Dublin Commuter Coalition
5 Abbeyfield
Killester
Dublin 5

ABP case ref: 313892

BUSCONNECTS BLANCHARDSTOWN CORE BUS CORRIDOR SCHEME

Figure 1 NTA's 'Dublin-style' junction at the Halfway House

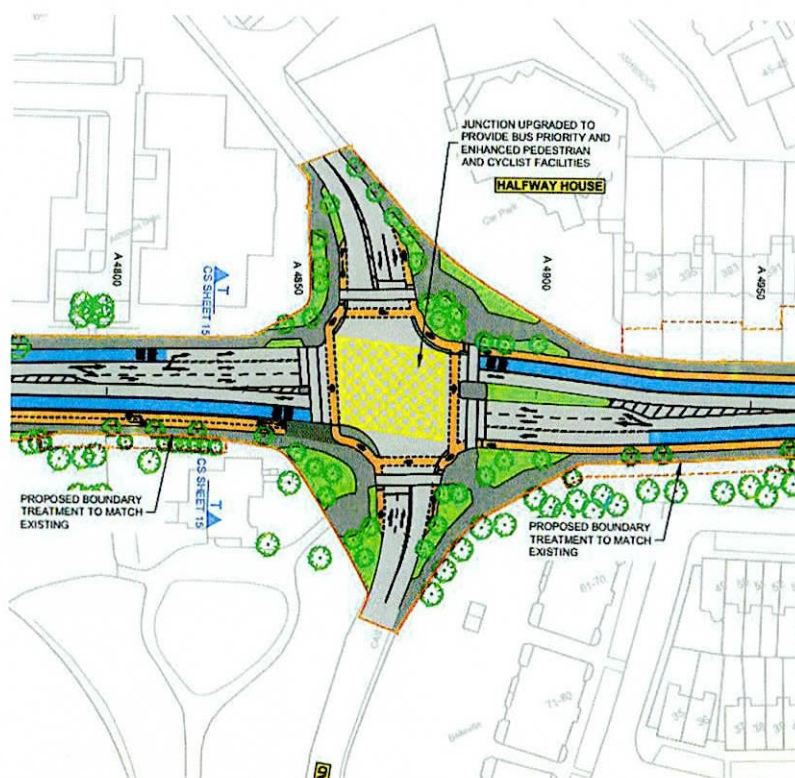
The primary junction design proposed by the National Transport Authority, the 'Dublin-style' junction (Figure 1), was designed by the NTA and does not follow international best practice in junction design.

When compared to the proven Dutch junction, the NTA's design poses a great risk of left-turning drivers crashing into cyclists and has larger crossing distances for pedestrians. The few existing examples of this NTA design in Dublin have been widely regarded as unsafe.

Figure 2 Dutch-style junction at Swords Road/Griffith Avenue from the second public consultation

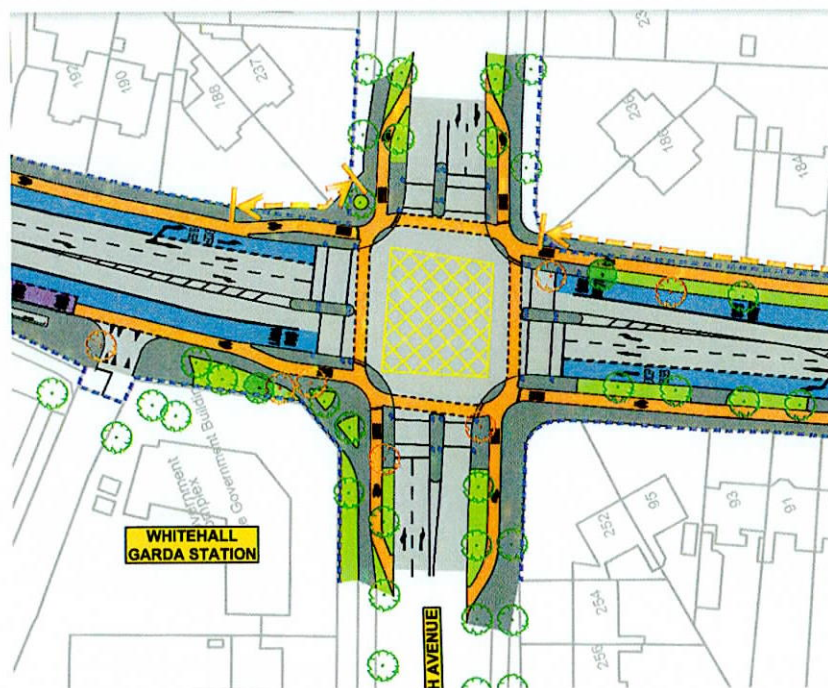
Two critical differences between a 'Dublin-style' junction and a Dutch-style junction (Figure 2) are that in a 'Dutch-style' junction (i) the waiting point for pedestrians is between the cycle track and the carriageway and (ii) the waiting point for cyclists going straight is substantially ahead of the waiting point of motorists who may be turning left.

We request that the NTA use Dutch-style junctions (Figure 2) throughout the project.

Figure 3: Junction at Blanchardstown Road and Old Navan Road

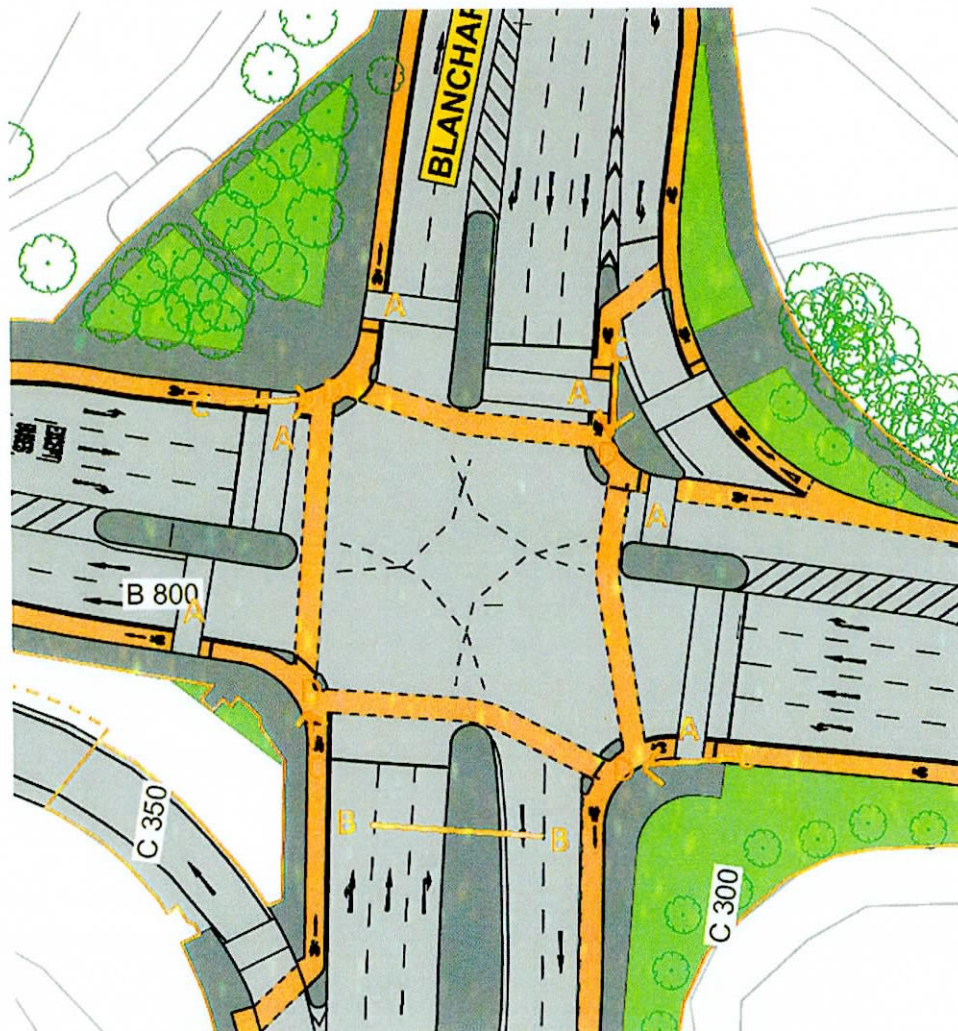
Firstly, two stage pedestrian crossings should be avoided. This can be achieved by installing pedestrian islands between the cycle lanes and the main carriage way. These would be at points A in Figure 3 below. This would somewhat reduce the distance for pedestrians to cross. If necessary, removing the pedestrian islands can further reduce the distance needed for pedestrians to cross and might allow the removal of these two stage crossings.

Further, there is no pedestrian crossing between the two B points in Figure 3. This missing crossing requires pedestrians to use the three other pedestrian crossings to legally cross here, and given these are two-stage crossings, that means a pedestrian may need to wait for six traffic light changes just to cross the street and continue their journey.

Currently cyclist starting points are beside motorist starting points. This ensures dangerous conflicts between cyclists going straight and motorists turning left.

Figure 4 below focuses on the top left corner of Figure 3 above. A cyclist moving forward at this junction will move from W to X. At the same time a motorist moving from Y to Z will not see or anticipate the cyclist moving to X. A motorist is likely to be travelling at speed by the time they reach Z. This conflict between motorists and cyclists is highly dangerous. It is likely to lead to collisions. And given the high fatality rate in motorist/cyclist collisions, it is possible it will lead to cyclist fatalities.

In order to avoid these conflicts, the waiting point for cyclists going straight should be substantially ahead of the waiting point of motorists who may be turning left. In Figure 3 above, this would involve moving the cyclist waiting point from points C to points D. This would result in cyclists going straight being visible to motorists turning left and would allow motorists time to react and turn left with the caution needed.

A pedestrian crossing should be installed at this junction. And appropriate pedestrian islands between the cycle lanes and the main carriage way should be installed.

Additionally, appropriate changes should be made to traffic light signalling for both cars and cyclists to ensure the junction is safe. (For example, this might involve an early green light for cyclists and a flashing amber light for motorists turning left.)

Figure 5: Junction at Blanchardstown Road and Old Navan Road – Bridge over N3

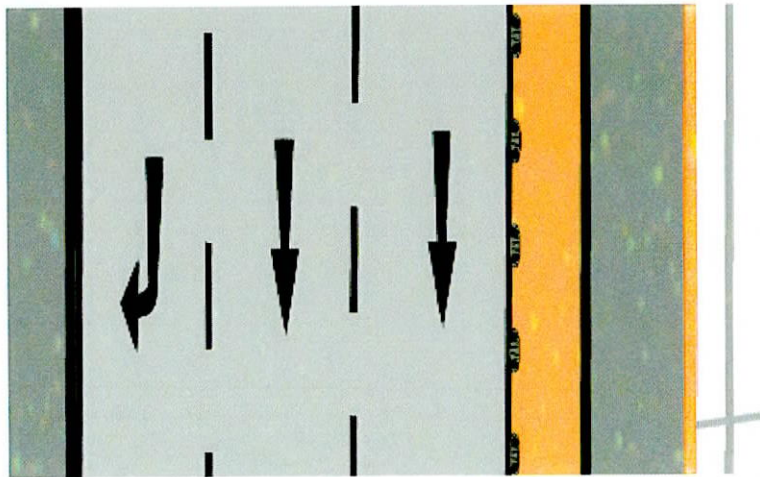
Below this junction, the Blanchardstown Road crosses the N3 with a bridge. On this bridge, these planning proposals have three lanes of traffic in each direction. But it only provides an extremely narrow cycle lane, with "light segregation" (i.e. armadillos). (See Figure 5.) A safe and sufficiently wide and properly segregated cycle lane should be provided.

Figure 6: Junction at Blanchardstown Road and Navan Road (N3) slip road

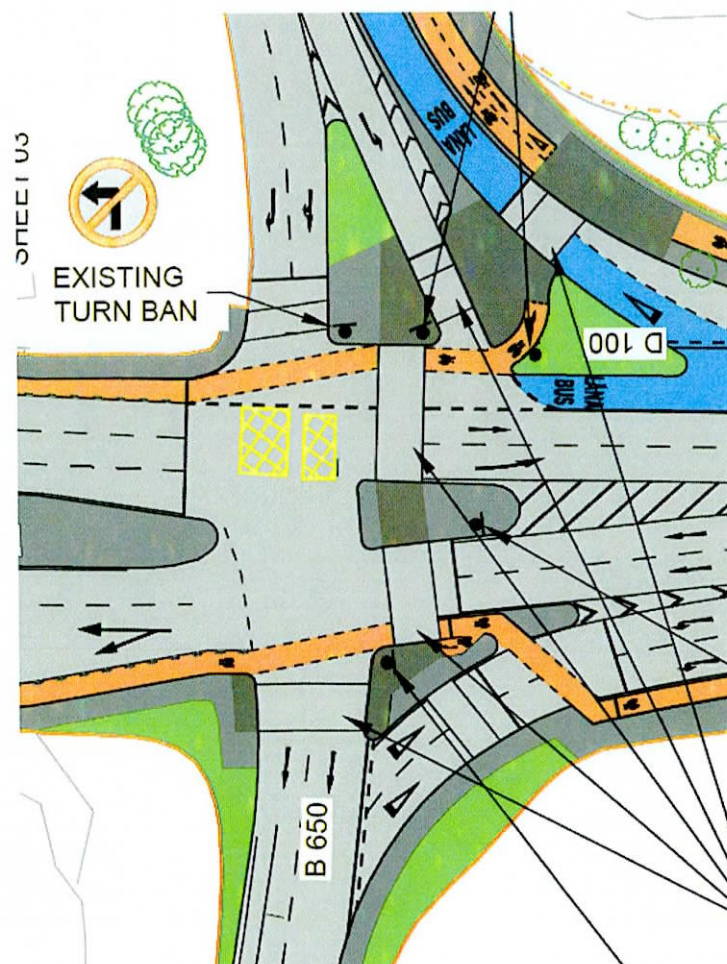
The junction at Blanchardstown Road and Navan Road (N3) slip road (Sheet 3) is very poor and the cycle crossing are complicated and unnatural. (See Figure 6 below.) And there is an excessive amount of shared cyclist/pedestrian space.

Figure 7: Junction at Blanchardstown Road and Blakestown Way – Cyclist/Pedestrian Interaction

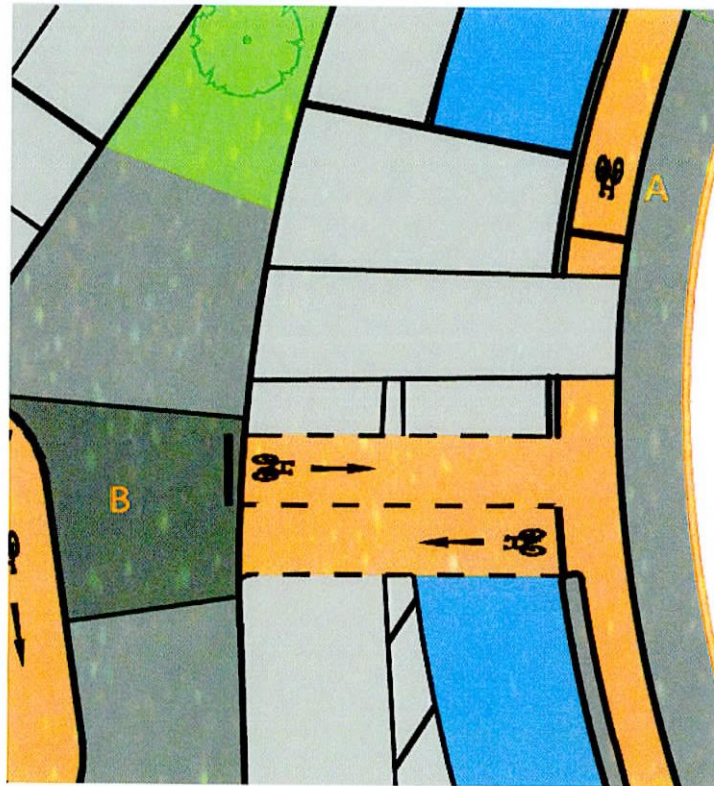
In Figure 7 below, at point A cyclists are supposed to yield for pedestrian traffic lights. But 5-10 metres later at point B they cycle on the footpath in "shared space" with the same pedestrians.

Figure 8: Junction at Blanchardstown Road and Blakestown Way – Cycle Junction

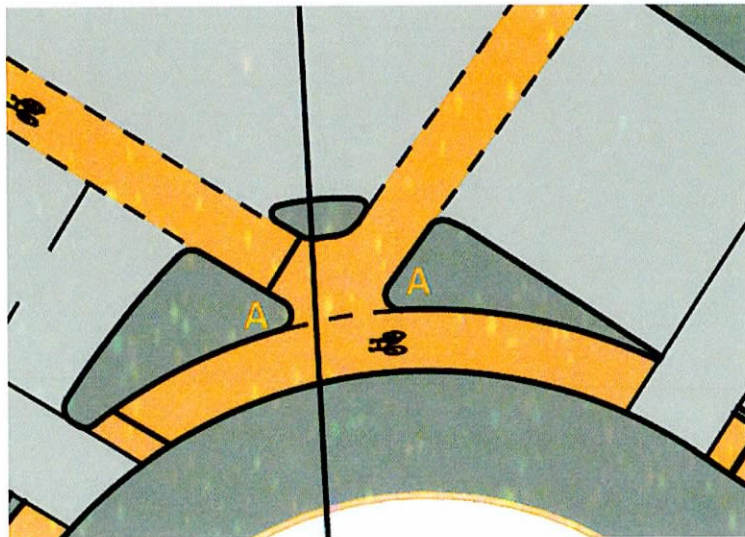
In Figure 8 below, the points A where this island sticks out into the cycle lane serve no purpose. But they would significantly impede cyclists going straight through the junction and not turning left. They are a recipe for minor accidents as cyclists will hit these kerbs as they oddly jut into the cycle lane. This type of bizarre design would not happen with road space for motorists.

Figure 9: Junction at Blanchardstown Road and Blakestown Way

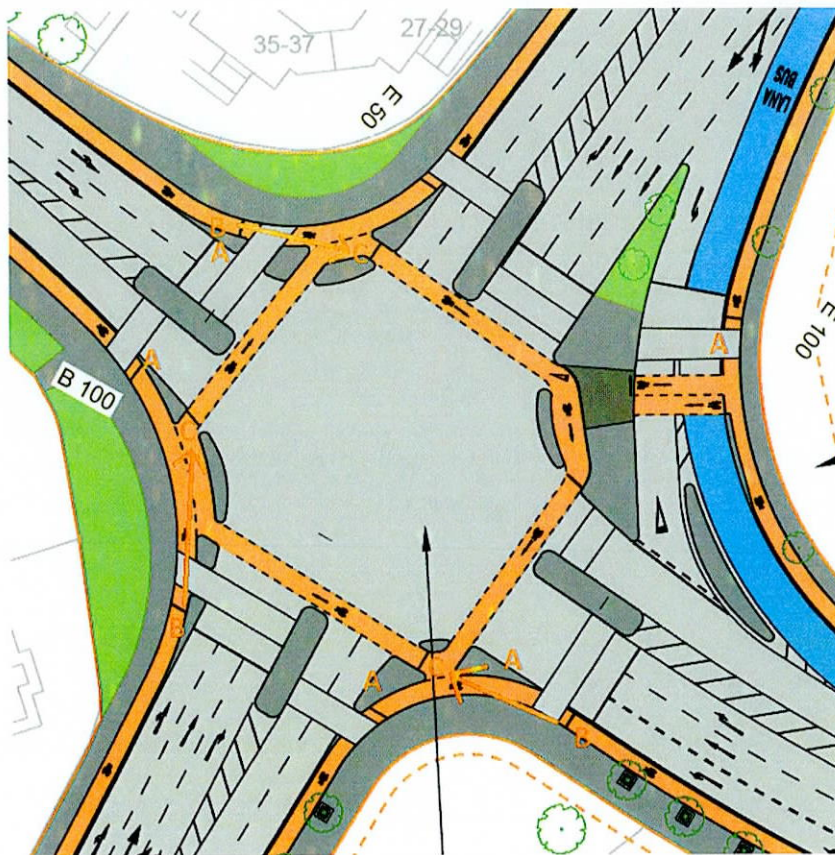
Moving on to the junction as a whole, most of same comments made above regarding the junction at Blanchardstown Road and Old Navan Road apply.

Pedestrian islands between the cycle lane and the main carriage way should be created at points A in Figure 9 below. Cyclist waiting points should be moved from points B to points C. And appropriate adjustments to traffic signalling should be made.

Figure 10: The New Blanchardstown Bus Station

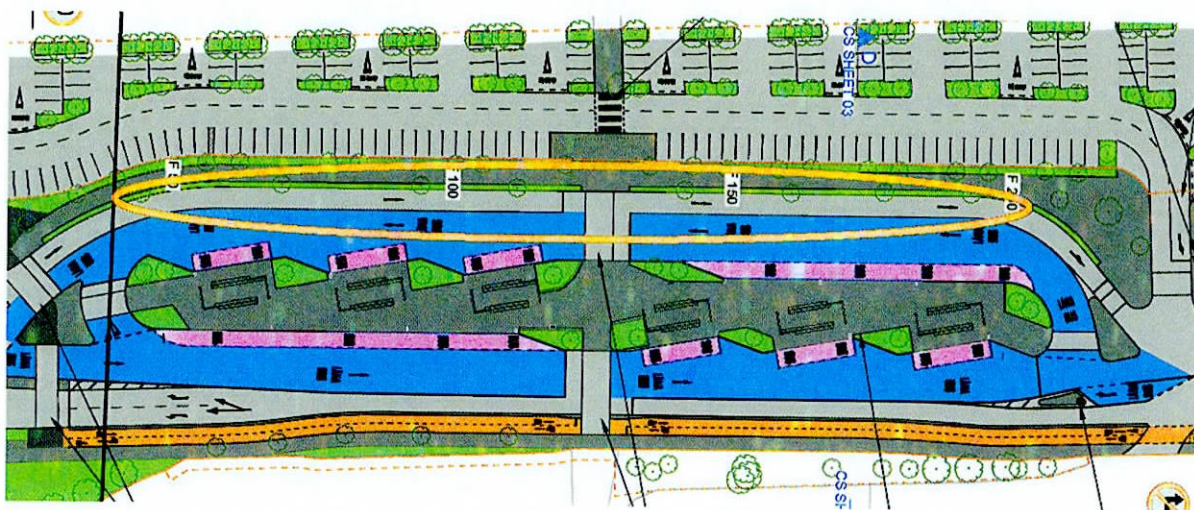
We don't fully understand the purpose of the road we have circled in red in Figure 10 below.

Running directly parallel with this road a matter of metres away is a two-lane road. We appreciate this is within a car park, but, if necessary, adjustments to this road could be made. It would make more sense to use that road for car traffic than to have car traffic unnecessarily run through the bus station where there are likely to be many pedestrians.

The same applies to the road below the bus station in Figure 10 above. This road does not need to be there. It could very easily be outside the bus station. For example, it could be above it with the road moving in the opposite direction.

Figure 11: Junction South of New Blanchardstown Bus Station

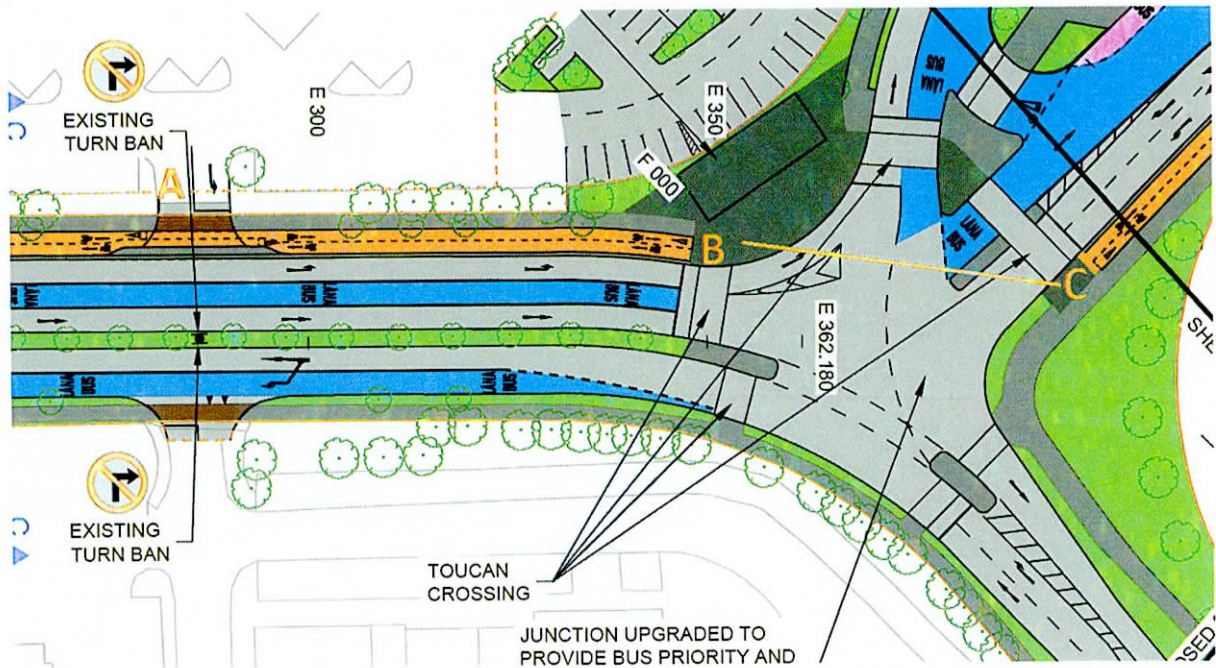
In Figure 11 below, cars could then enter and exit at point A and the missing connection between the bike lane at points B and C could be created. Currently, there is no connection these two points at all. The two cycle lanes simply end and apparently zero thought has been given to what cyclists should do at this point apart from dismount and walk or cycle on the footpath.

Figure 12: Junction North of New Blanchardstown Bus Station

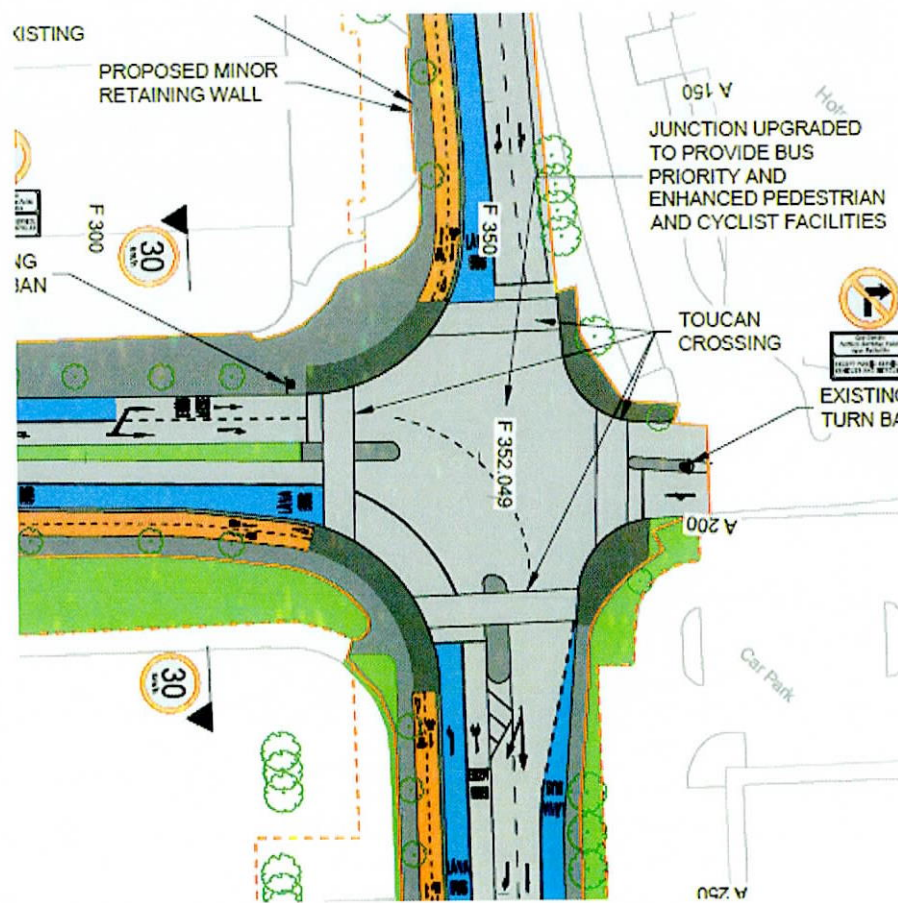
The junction at the exit of the bus station is better but not much better. The shared cyclist/pedestrian space in Figure 12 below should be replaced with segregated cycle lanes and pedestrian islands between the cycle lane and the main carriage way.

Figure 13: Between Blanchardstown Bus Station and the Snugborough Junction

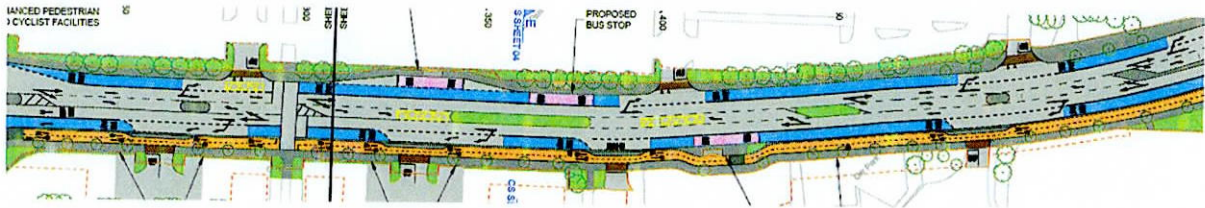
On the road from the new bus station and towards the Snugborough Junction (Sheet 6), there are a very large number of interruptions to the bus lane. (See Figure 13 below.) We think that alterations should be made here to ensure bus priority and to prevent private motorists from slow bus traffic here. For example, yellow boxes might be worth placing in front of all these entrances.

Figure 14: Junction before Snugborough junction

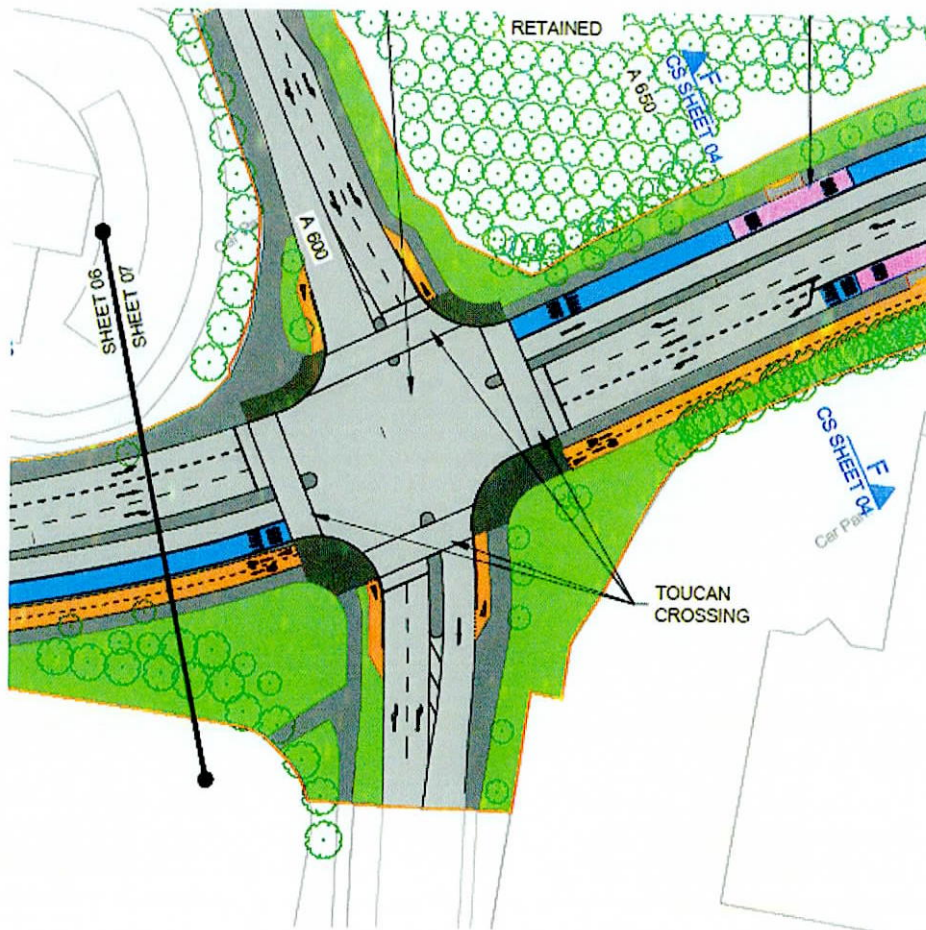
Replacing the roundabout at the next junction (Sheet 7) with a signalised junction is welcome, however the junction as shown in figure 14 below should be improved. The shared pedestrian/cyclist space should be replaced with segregated cycle lands and proper pedestrian islands between the cycle lanes and the main carriage way.
